A 31/3/22 Section 4.55 Application

Rev Date A06 13 Morgan Road Belrose 2085 31/3/2022 Drawn by Checked by Revision AUST01 JDP JLP

Drawing Notes Revision Control	Client	Drawing	
	Jenny and David Austin	Elevation Shee	et 2
	Project	Scale	D
	Taronnah	1:100 @ A1	
	Project Address	Rev Date	
	13 Morgan Road Belrose 2085	31/3/2022	
	Project Code	Drawn by Checked by	R
B 31/3/2022 S4.55 Application A 11/2/22 CC Application	AUST01	JDP JLP	E

Client	Drawing	Drawing		
Jenny and David Austin	Shadow - 9am 21st June			
Project	Scale		Drawing Number	
Taronnah	1:300 @ A1			
Project Address	Rev Date		CU Oam	
13 Morgan Road Belrose 2085	31/3/2022		SH_9am	
Project Code	Drawn by	Checked by	Revision	
AUST01	JDP	JLP	В

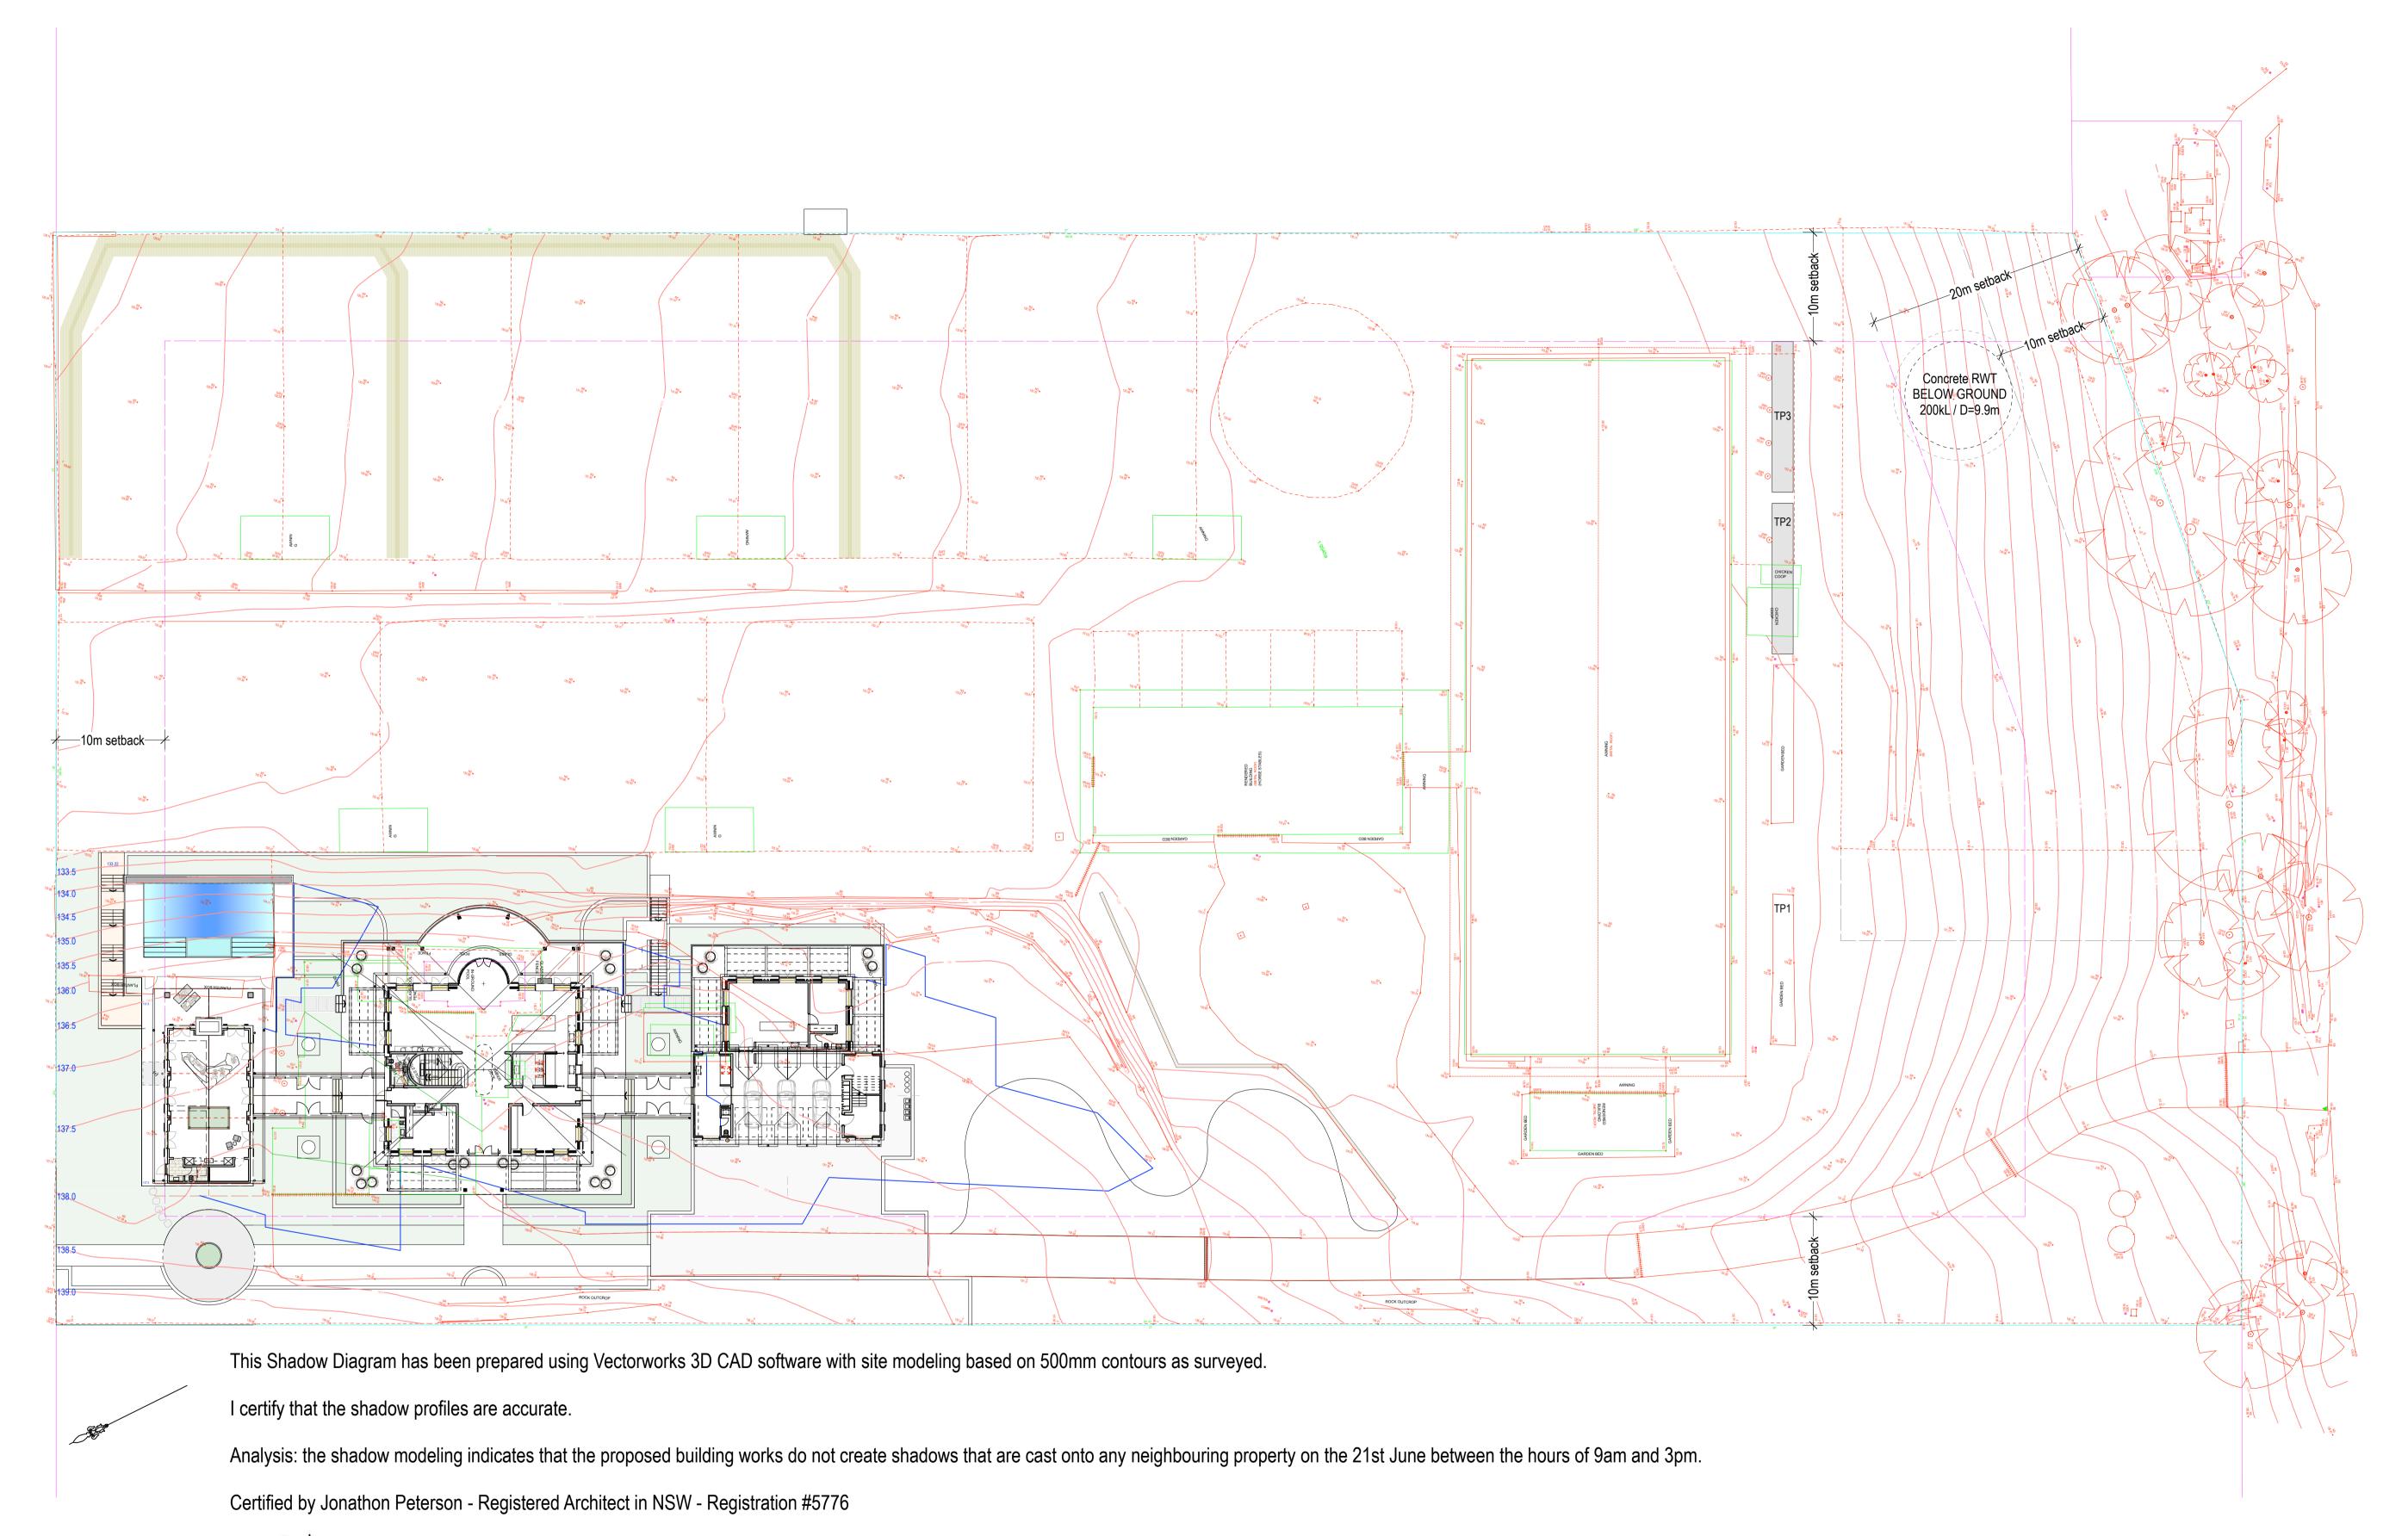
NO CHANGE to shadows as a result of this S4.55 application

Client	Drawing	Drawing		
Jenny and David Austin Shadows Noon 2		21st June		
Project	Scale		Drawing Number	
Taronnah	1:300 @ A1			
Project Address	Rev Date		CLI NIGOR	
13 Morgan Road Belrose 2085	31/3/202	22	SH_Noon	
Project Code	Drawn by	Checked by	Revision	
AUST01	JDP	JLP	В

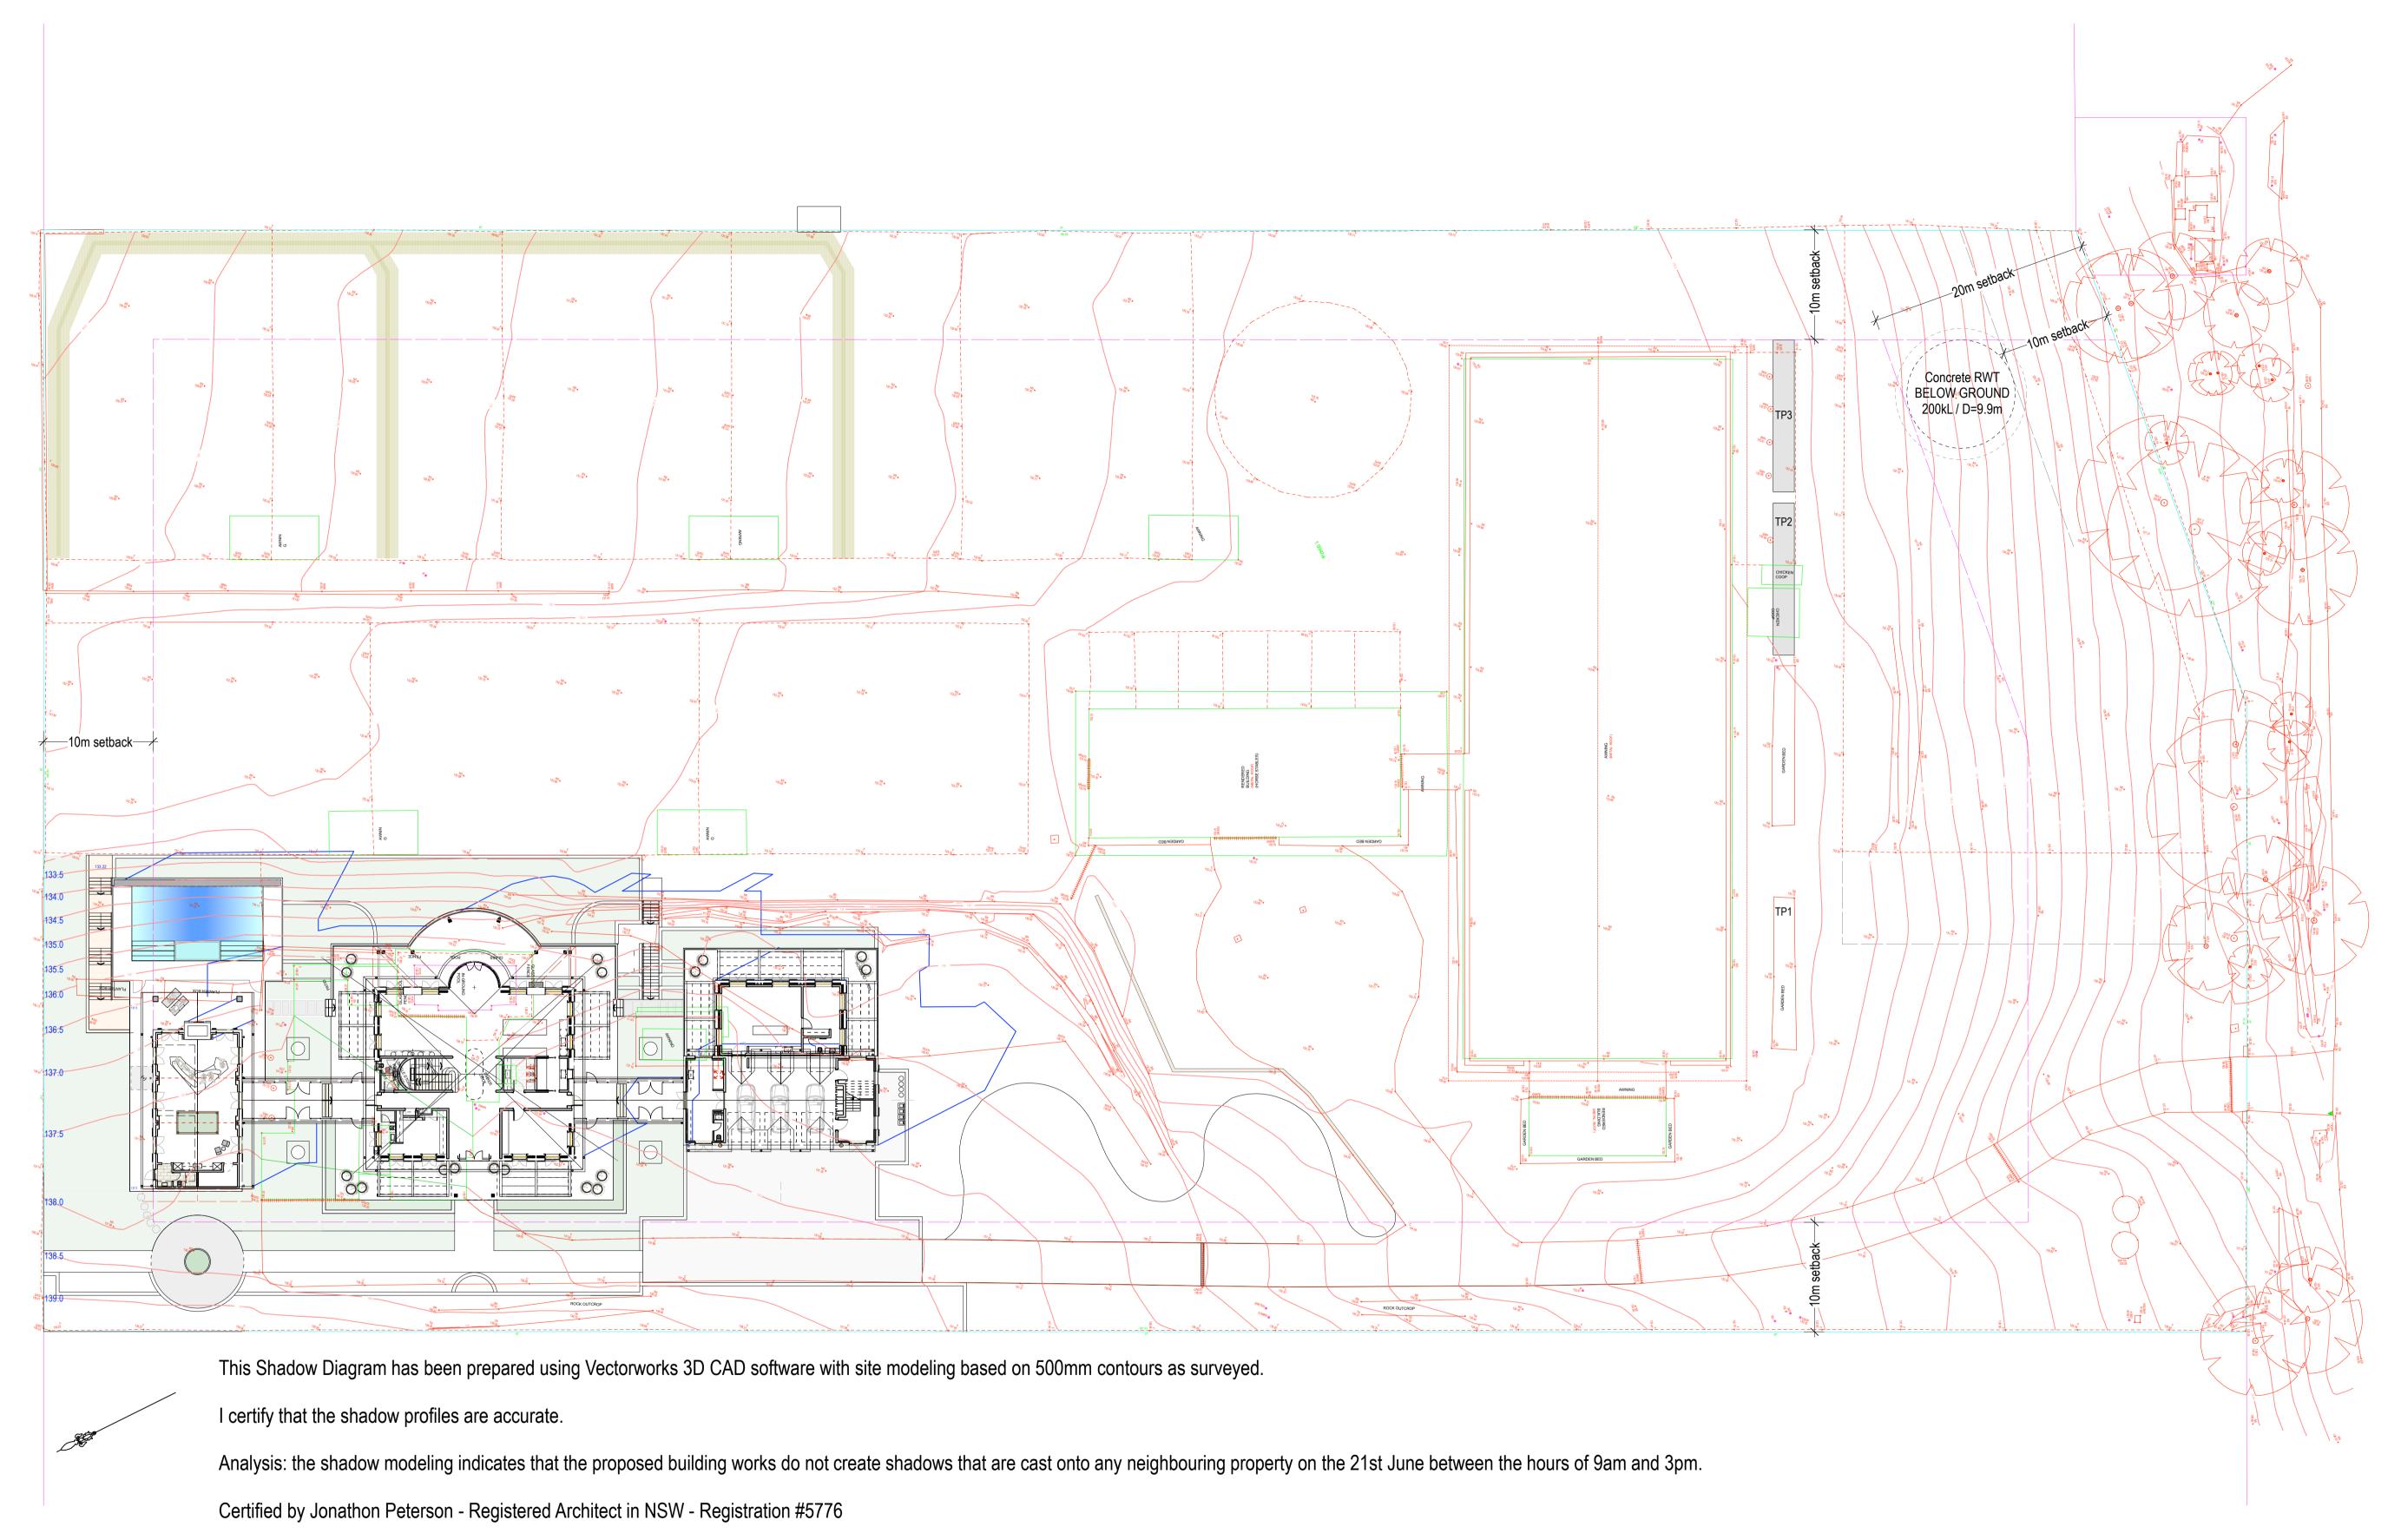
NO CHANGE to shadows as a result of this S4.55 application

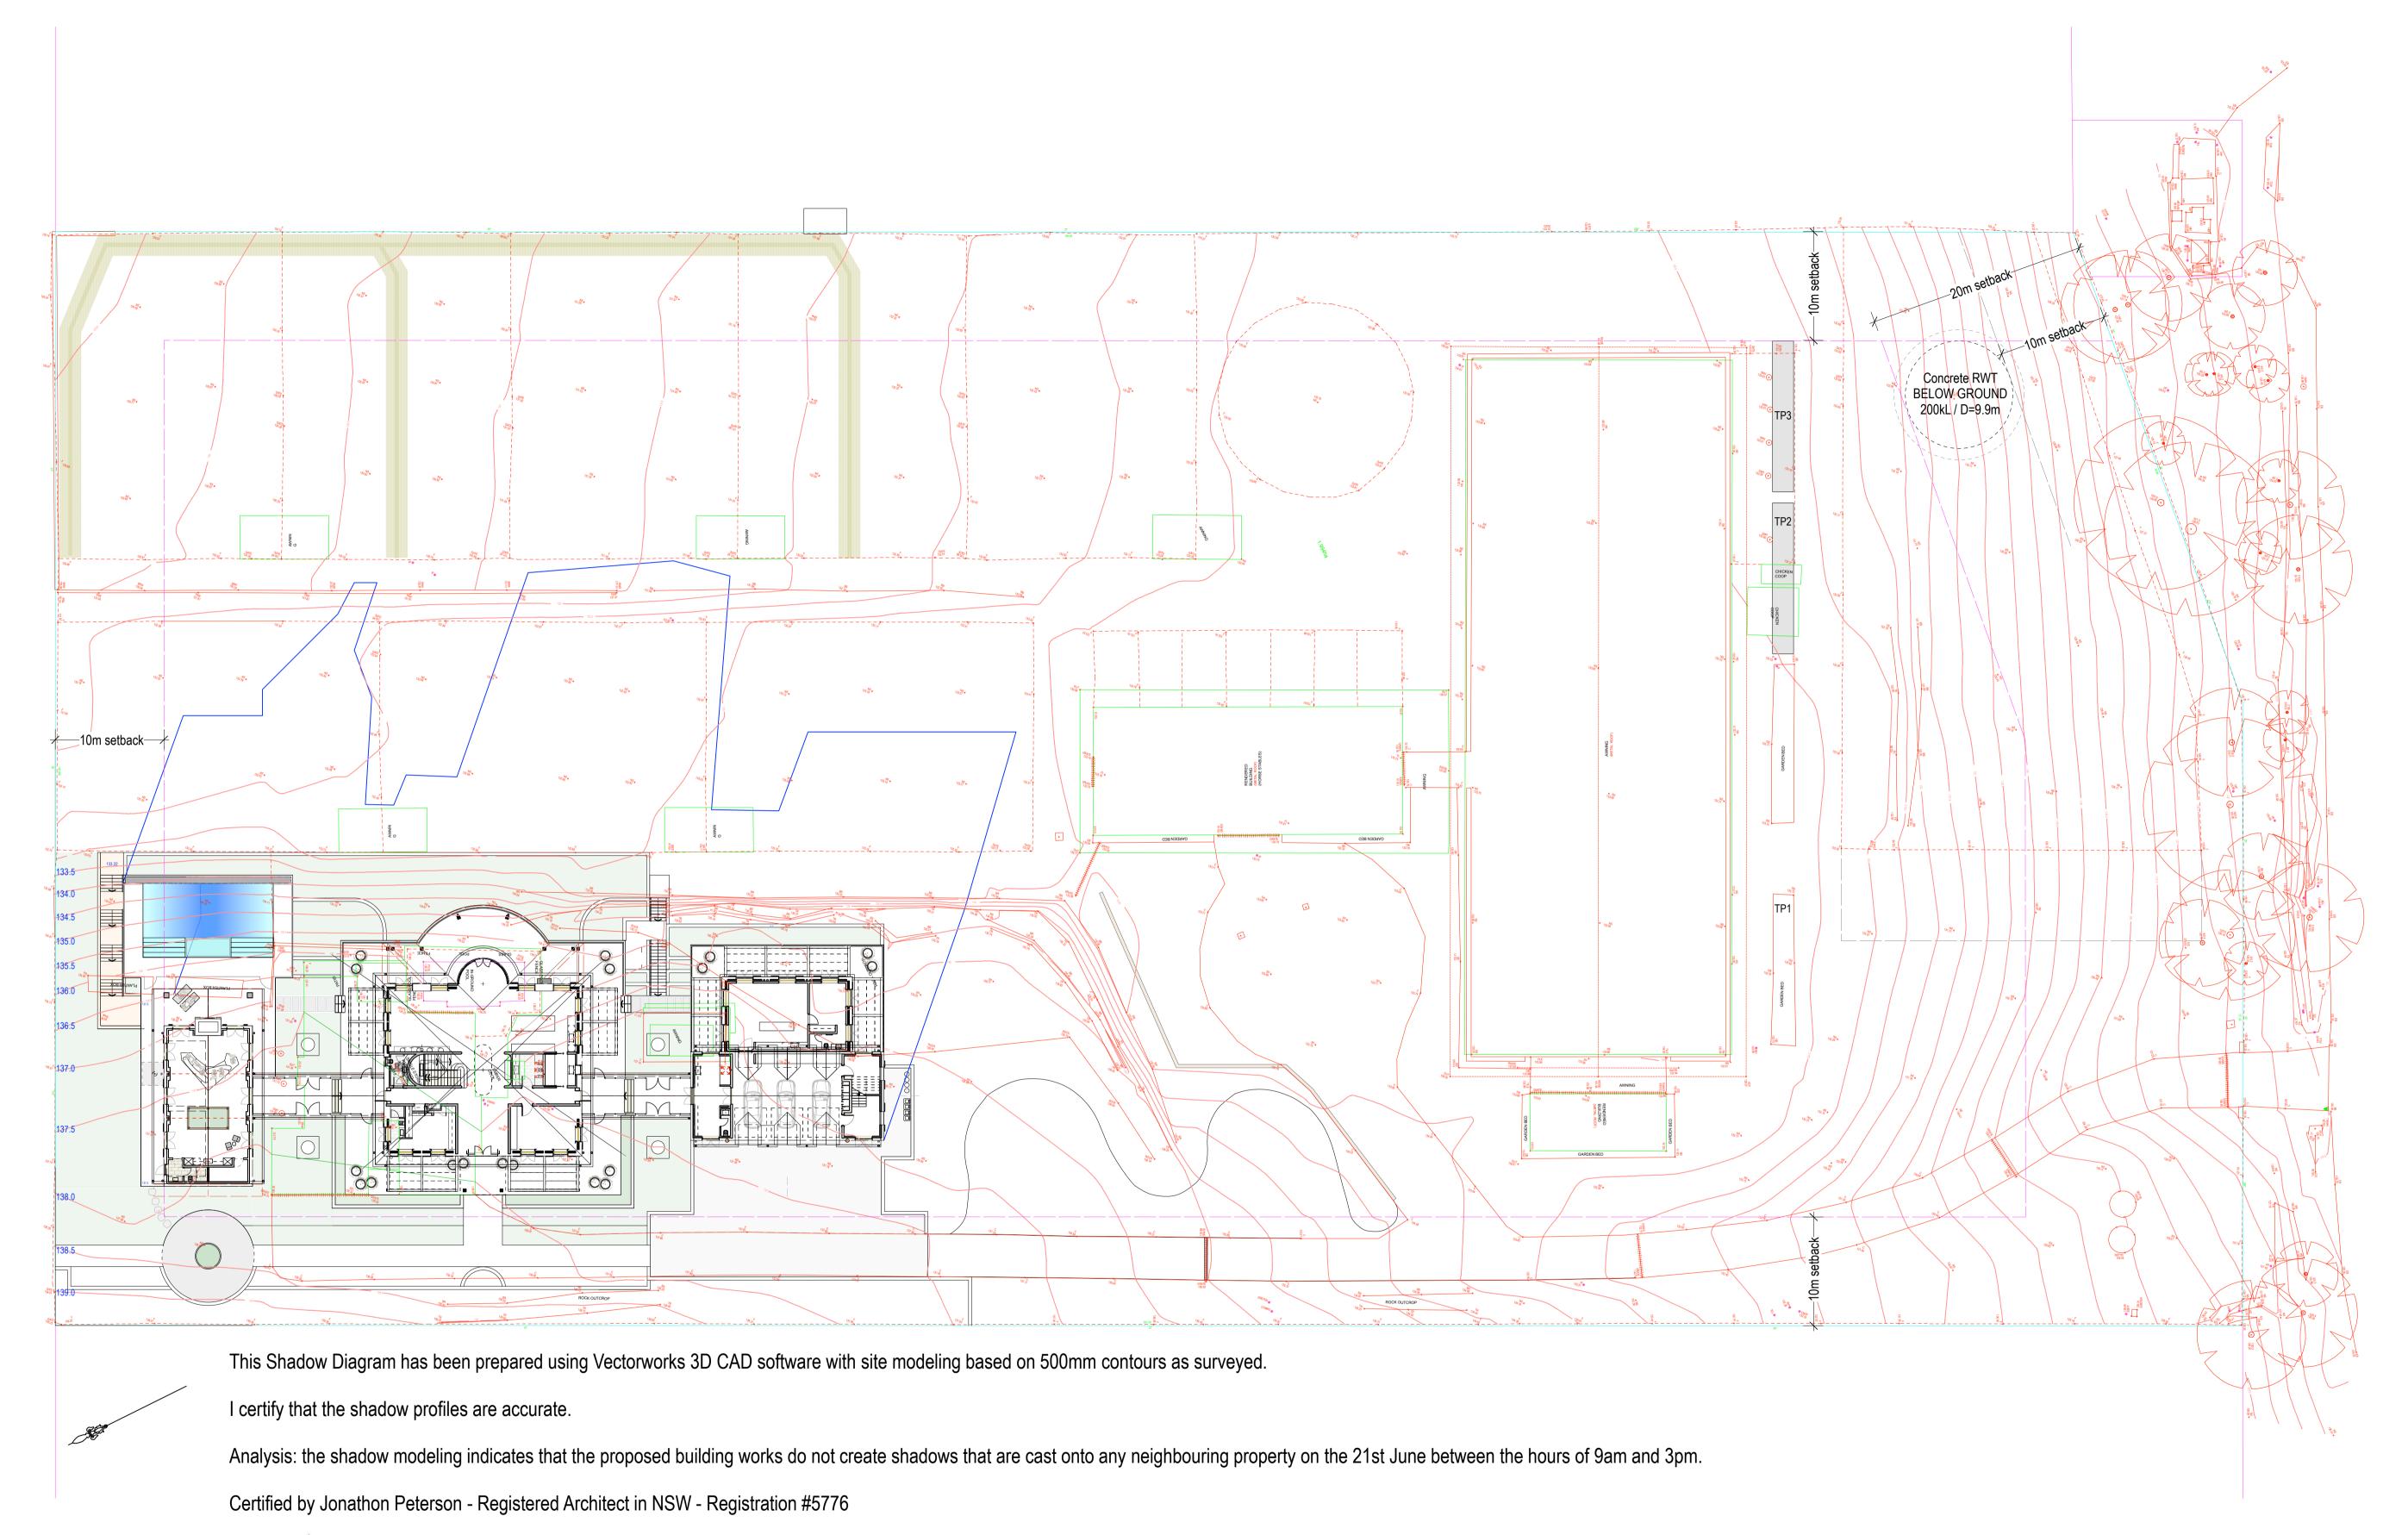
NO CHANGE to shadows as a result of this S4.55 application
